# Evaluation of Rosenbaum's Proposal for Locally Increasing the Effective Vertical Emittance of the APS Beam

M. Borland, L. Emery, N. Sereno  
AOD/OAG  
June 2002

*Figure 1: Illustration of Rosenbaum's scheme. Arrows show the extremal paths of the electron beam in the vertical plane.*

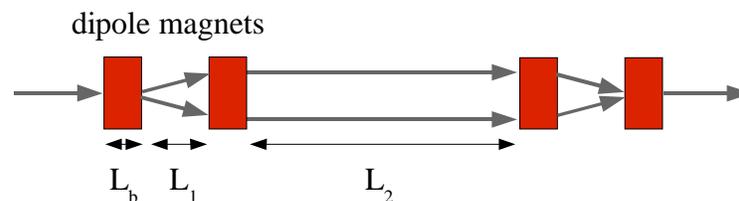
At the APS Retreat in May 2002, G. Rosenbaum proposed a method for increasing the effective vertical emittance of the APS beam. His proposal, illustrated in Figure 1, is to use a rapidly-modulated four-magnet vertical position bump in a single straight section. The proposed modulation frequency is a 10-kHz triangle wave, with a kick angle of 0.65 mrad. There are several aspects of this proposal that may be problematical:

1. The high modulation frequency will require the use of a ceramic chamber with a thin conductive coating, similar to what is used for the injection kicker magnets. This is not necessarily a problem, but the following aspects need to be examined:
  - (a) The chamber coating needs to be specified correctly to ensure that the beam motion reflects the desired triangle-wave pattern.
  - (b) The effect of the eddy currents in the chamber on the multipole content of the magnetic field needs to be computed, to ensure that the system does not have undesirable effects on the beam.
2. The magnets and their chambers will require careful matching in order to ensure that the beam is not disturbed outside of the bump. We know from experience with the APS kickers that this can be difficult.
